Heart of America Northwest

Joint Comments of Heart of America Northwest and
Heart of America Northwest Research Center on the
*Draft Tank Closure and Waste Management Environmental Impact
Statement for the Hanford Site, Richland, Washington*

May 3, 2010

Submitted to U.S. Department of Energy and Washington Department of Ecology

• Table U-2

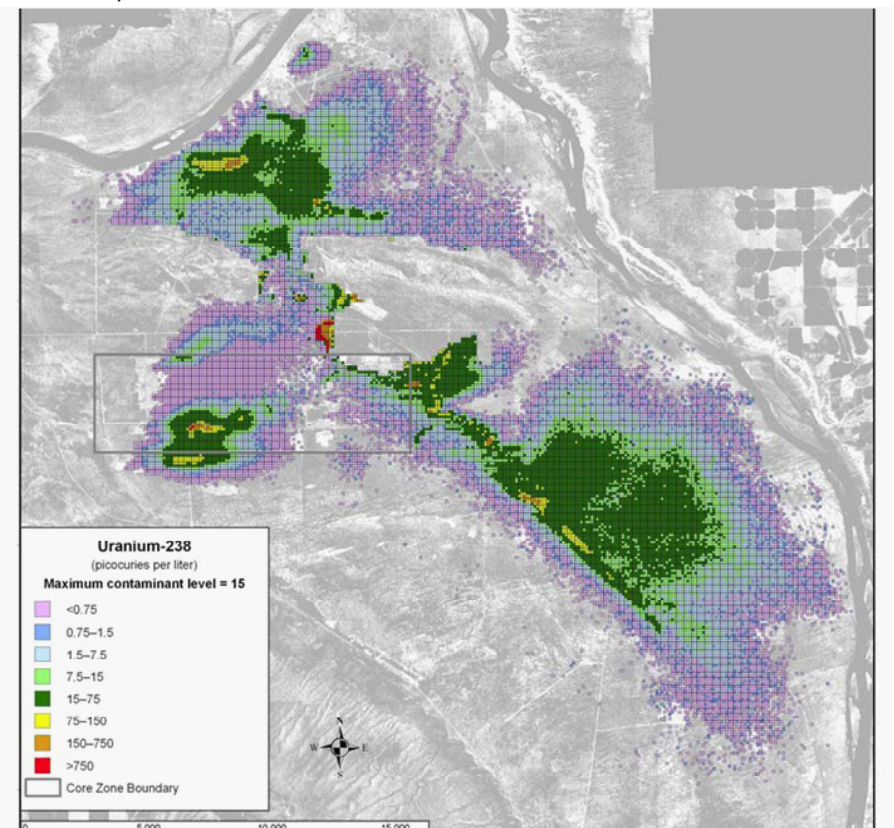
USDOE projects that Plutonium 239 levels at the River shore will increase to 300 times the Drinking Water Standard in the next thousand years under USDOE’s proposed actions, including from unlined discharge and burial grounds that USDOE plans to cap, instead of cleaning up

Figure 6–66. Alternative Combination 2 Spatial Distribution of Cumulative Groundwater Concentration for Uranium-238 During Calendar Year 3890 . Discussion page 6-70.

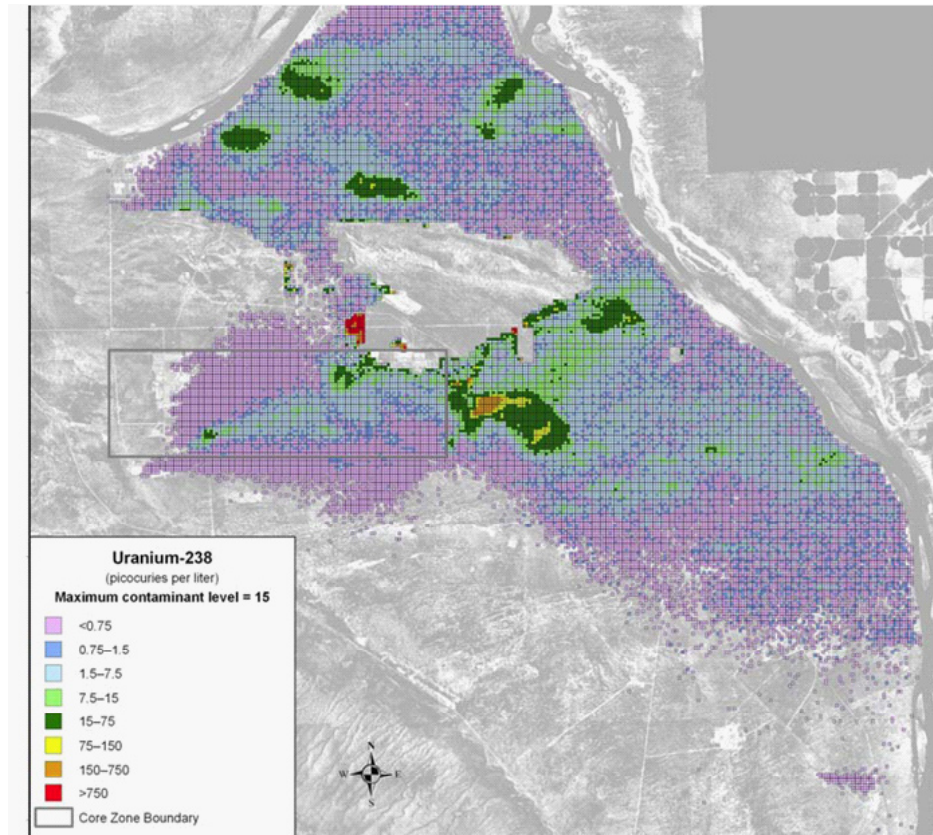
The draft TCWMEIS fails to provide maps or charts disclosing the cumulative risk from all contaminants to Native American children and other reasonably foreseeable exposed populations over time. It is very foreseeable that the scarcity of water, including restrictions on further Columbia River withdrawals and the projected decrease in River flow due to climate change, will lead to use of the immense groundwater resource under Hanford.

Note that the area USDOE uses to report groundwater contamination levels is what it refers to as the “Core Zone Boundary”, shown in charts as the box on the Central Plateau. This exceeds the 200 Area fence lines, and is a significant distance from the boundaries of the regulated hazardous waste units – allowing for significant dilution in groundwater before reaching the location USDOE is reporting on. Hazardous waste laws, however, require meeting the drinking water standard at the boundary of the unit itself – not allowing USDOE to contaminate large areas outside the units.
